**Work Order ID 89877****\*89877\***

Item Name: Crosstube Assembly, Mid Aft

DART AEROSPACE LTD	Work Order:	89877
Description: Crosstube Assembly, Mid Aft	Part Number:	D206-667-247TRN
Inspection Dwg: D206-667-247 Rev: A		Page 1 of 2

DRAWING NO. D206-667-247	TITLE CROSSTUBE ASS'Y (206L MID AFT)	REV. A	DART AEROSPACE LTD ENGINEERING ORDER	D.E.O. NO. D206-667-247-A-1	SHEET NO. SHEET 1 OF 1	SCALE NTS
DRAWN <i>qd</i>	CHECKED <i>ASS</i>	MFG. APPR. <i>KD</i>	APPROVED <i>JW</i>	DE APPR. <i>MM</i>		
DATE 11.07.15	DATE 11.07.20	DATE 11.07.21	DATE 11.07.21	DATE 11.07.21	DATE 11.07.21

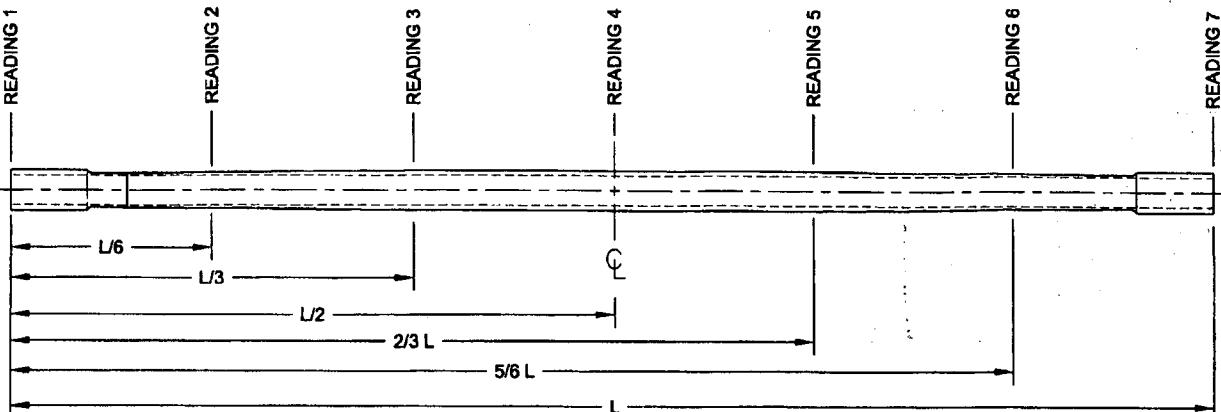
Doc/Data	12/9/21	100	1	HALF of tube, as well as both Cuffs are out of tol.  worst Cuff $\rightarrow$ 2.486" - 2.480" $\rightarrow$ tol = 2.490"	DAS 12 0-88	Acceptable.  All taper dims are above min. tolerance  G1 12/9/21	12/9/21	12-9-25	JW	
Equip/Tooling										
Operator										
Material										
Setup										
Other										
Process										
Supplier										
Training										
Unapproved

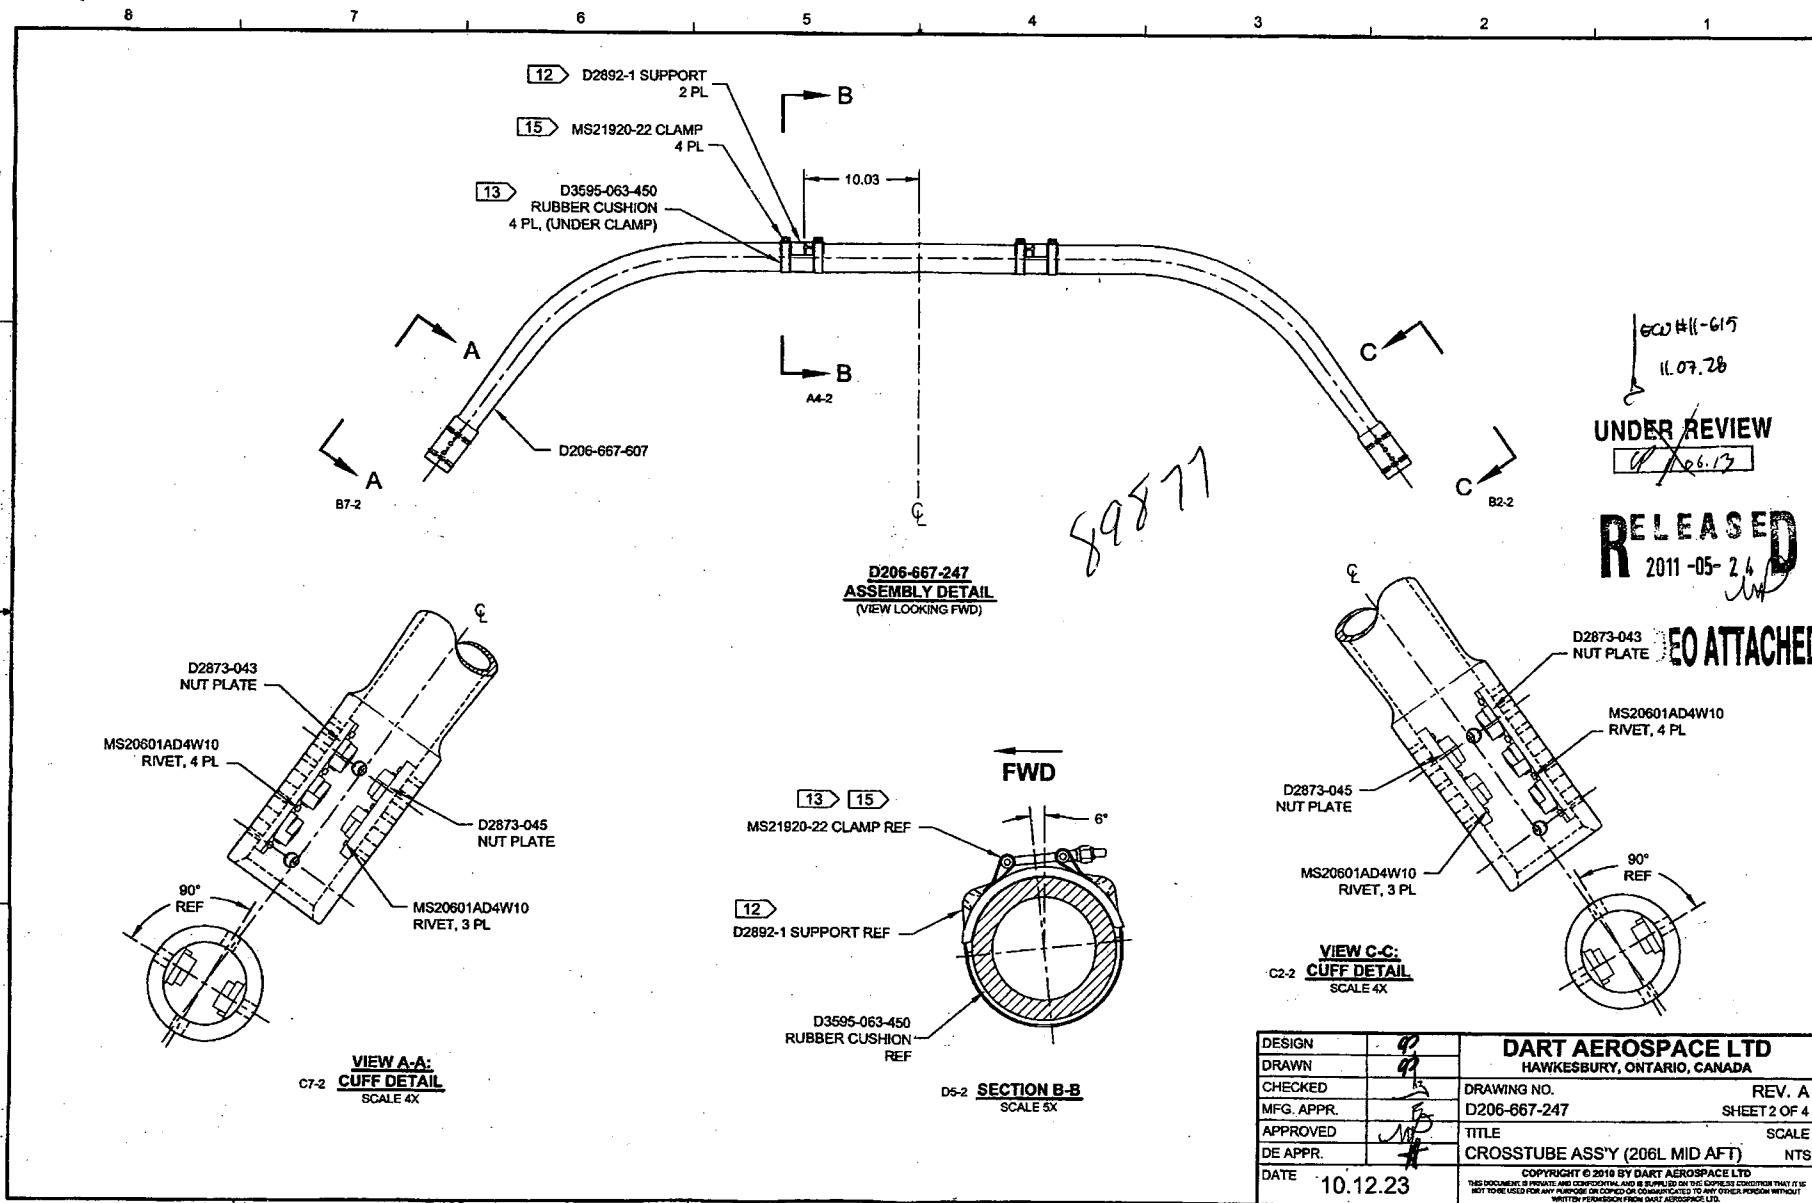
REPLACE MAGNOBOND WITH PROSEAL.

NOTE 12 & 15, SHEET 1 IS AMENDED AS FOLLOWS:

12) TO INSTALL D2892-1 SUPPORT: ABRADE MATING SURFACE OF SUPPORT AND CROSSTUBE WITH 180-GRIT SANDPAPER AND REMOVE RESIDUE WITH MEK (OR EQUIVALENT). APPLY A 0.04" TO 0.07" THICK LAYER OF PROSEAL 890 CLASS B-2 (OR AMS-S-8802 CLASS B-2) SEALANT TO MATING SURFACE OF SUPPORT.

15) TORQUE CLAMPS 80 TO 100 IN-LB. ENSURE AT LEAST 1.5 THREADS SHOWING IN SAFETY AND THAT NUT HAS NOT BOTTOMED-OUT AFTER TORQUING. PRIOR TO PACKAGING, RE-CHECK TORQUE ON CLAMPS AFTER PROSEAL 890 SEALANT HAS CURED FOR 72 HOURS.
